Petition No. 1385

PETITION NO. 1385 BERT DEARING JR. 2727 RUSSELL ST. DETROIT, MICHIGAN 48207 PHONE NO. 313 567-2030

REQUEST ENCROACHMENT INTO RUSSELL AT 2727 RUSSELL (With Outdoor Seating)

CIT'	Y OF DETROIT					
CITY ENGINEERING DEPARTMENT						
SURVEY BUREAU						
JOB NO.	01-01					
DRWG. NO.	X 1385

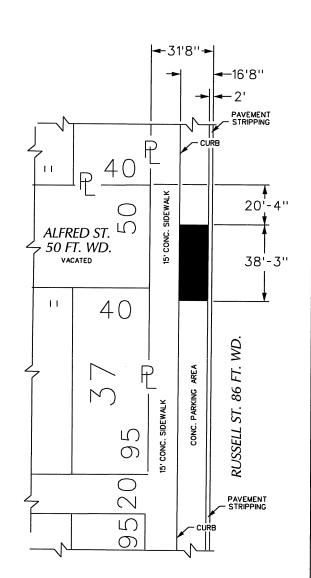
- () Involved; but no objections to the property change provided an easement of the full width of the public right-of-way (street, alley or other public place) is reserved.
- () Involved; the nature of our services, and the estimated costs of removing and/or rerouting such services are:
- (X) Involved. The request for encroachment into Russell at 2727 Russell (with outdoor seating) as shown on drawing no. x1385 dated 3/14/2017 and drawing no. A-101 revised on 4-5-2017 is approved provided that the following conditions are met:
 - The petitioner shall install a platform/surface to raise the level of the area under the proposed outdoor seating patio thereby creating a surface which is level with the sidewalk adjacent to it.

The petitioner shall install railing along the boundary of the outdoor seating patio adjacent to the west edge of the travelled roadway of southbound Russell St.
